Amendments to the Figures:

REMARKS/ARGUMENTS

Int. Appl. No.: PCT/US02/15387
U.S. Appl. No.: 10/706,925
Amdt. dated: July 19, 2005

Annotated Marked-up Drawings

FIG. 1a

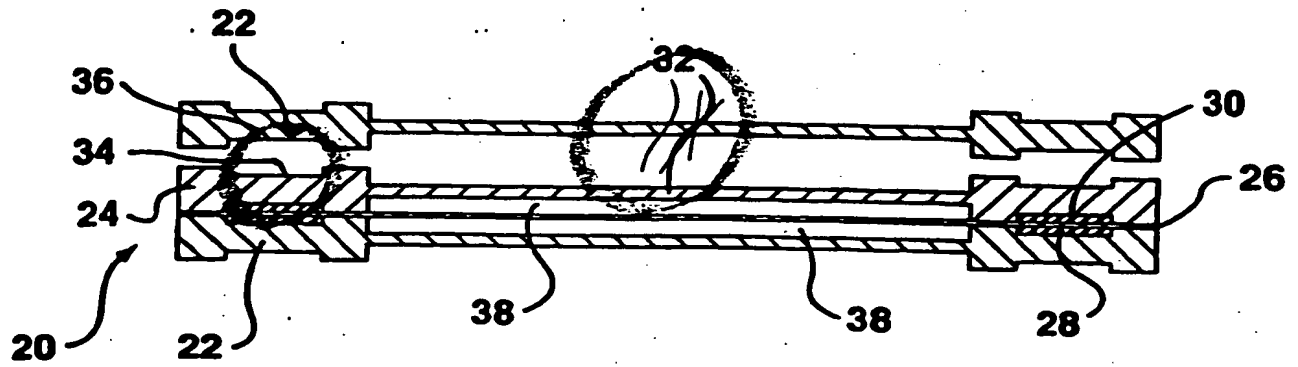
With respect to the drawings, amendments are being made to Figures 1a-e, 2, 7-12, and 17. In Figures 1 and 2, the amendments to the lead lines are intended merely to ensure that these drawings are wholly consistent with the specification and to aid in understanding the drawings. In Figure 7, the connection apertures have been labeled with reference numeral 160. In Figure 8, for consistency with Figure 7, the references 137, 139 and 141 now denote ports on the left hand side, while references 136, 138 and 140 denote ports on the right hand side. In Figure 9, the connection apertures have been labeled with reference numeral 160. In Figure 10, the reference numerals 182', 184' and 186' are, in effect, being switched with the reference numerals 182a', 184a' and 186a'. In Figure 11, at the right hand side reference numeral 160e has been

FIG. 11

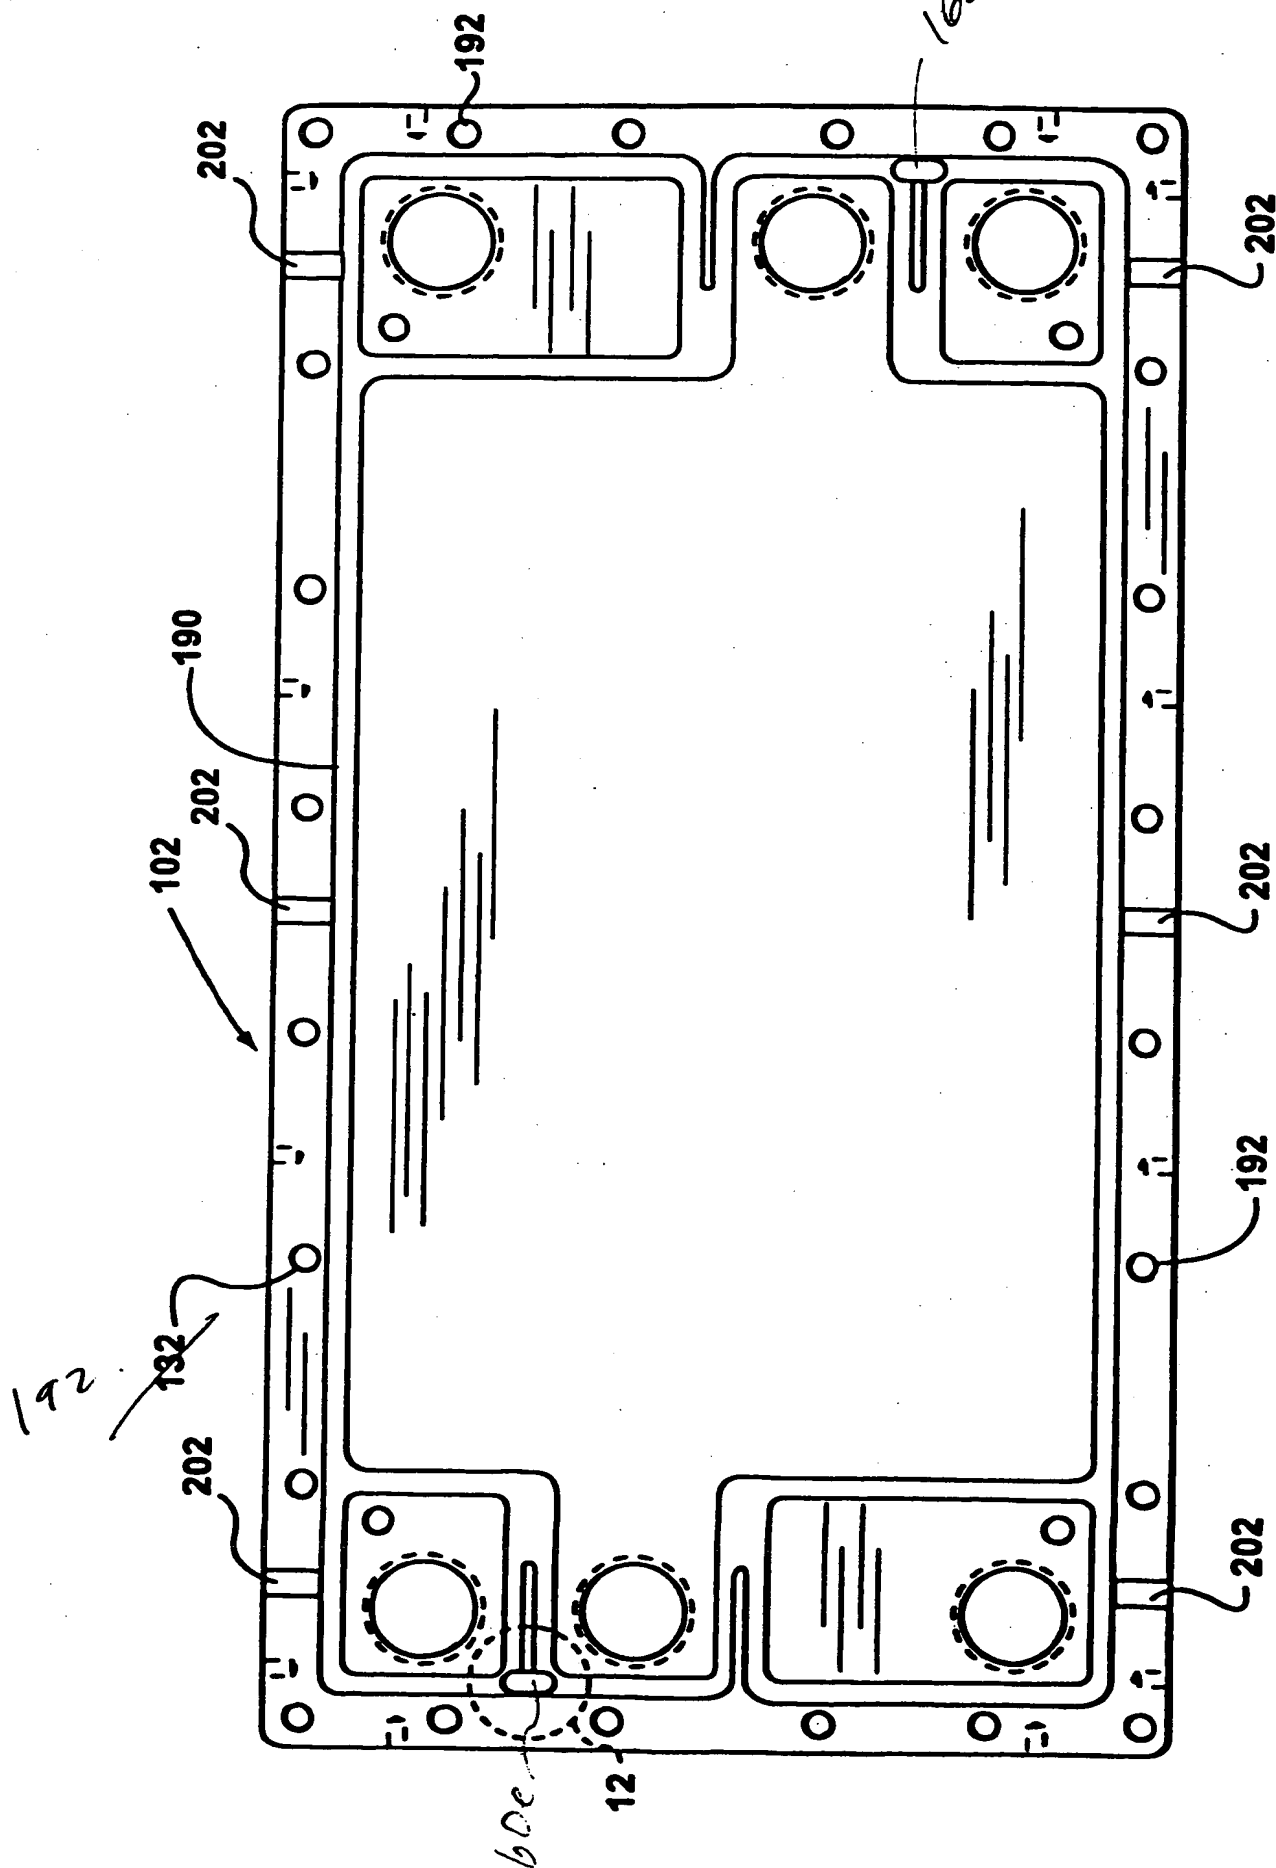
amended to read 160ae and the reference 160e added on the left hand side; at the top 132 has been corrected to 192. In Figure 12, the sealing aperture has been labeled with reference numeral 160e. In Figure 17, the lead line for reference numeral 146 has been extended to point to the sealing groove to ensure that the drawing is wholly consistent with the specification. These amendments are simply intended to ensure consistent use with the reference numerals used in the Figures and the description and for clarity in the drawings.
